Determination 2019/001

Regarding the code-compliance of sliding and hinged doors that form part of a barrier to a pool at 14 Galatea Terrace, Herne Bay, Auckland

This determination considers the code compliance of sliding and hinged doors that form part of the barrier to a pool. The determination assesses the barrier against the performance requirements of Building Code Clause F9 – Means of restricting access to residential pools.

Figure 2: Testing the self-closing system at the first site visit

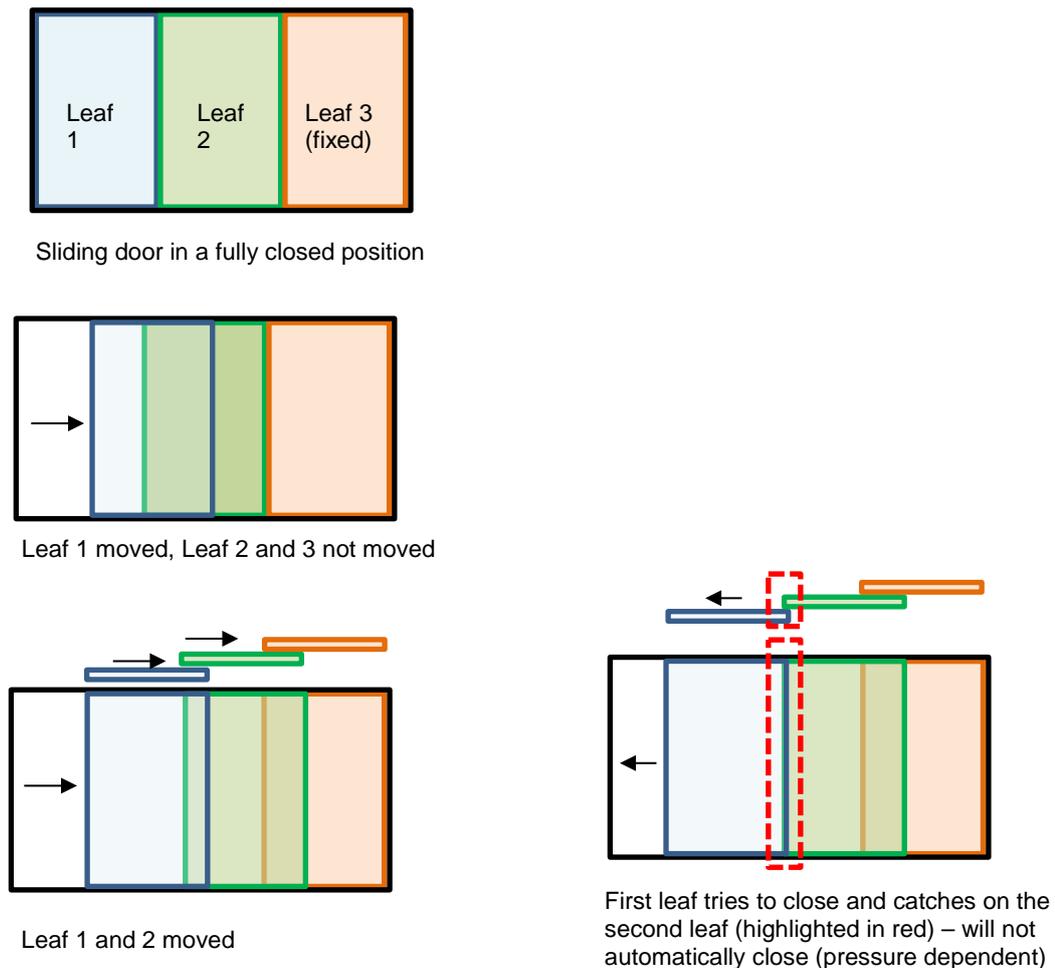
- 4.5 To test the authority's concern (refer Table 1 "Compliance of the sliding door and hinged doors") the second leaf was moved while the first leaf was partially open (see Figure 2). There was no difficulty in opening the second leaf, although another person was required to open the first leaf. I observed the second leaf didn't require

- the first leaf to be fully open for it to be able to move. When the first leaf was released it caught on the second leaf and could not automatically close because the mechanism, set at its current pressure, was not strong enough to close both leaves.

Figure 3: Sketch of proposed doors with safety features disabled

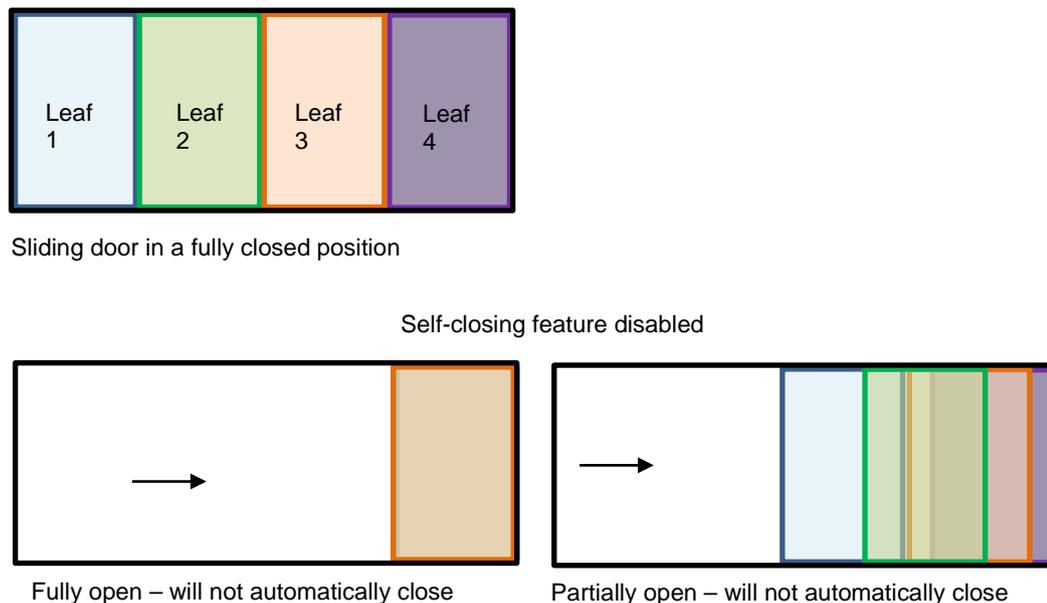
- 5.4.9 In this case, the mechanism is designed to allow for the sliding door and hinged doors to be kept open (see Figure 3). I note all of the doors could be kept open when the mechanism is disabled because three leaves of the sliding door and both hinged leaves are proposed to be openable. Compliance then relies solely on the vigilance of a person to reinstate the barrier to be effective. This is a weakness of the proposed barrier that doesn't exist with a compliant door or pool gate.

5.4.21 In conclusion, I consider both the sliding door and hinged doors as proposed to be amended and fitted with the mechanism are designed in such a way that they do not always automatically return to the closed position after use. Therefore, the doors as the barriers do not comply with Clause F9.3.4(a)(ii).
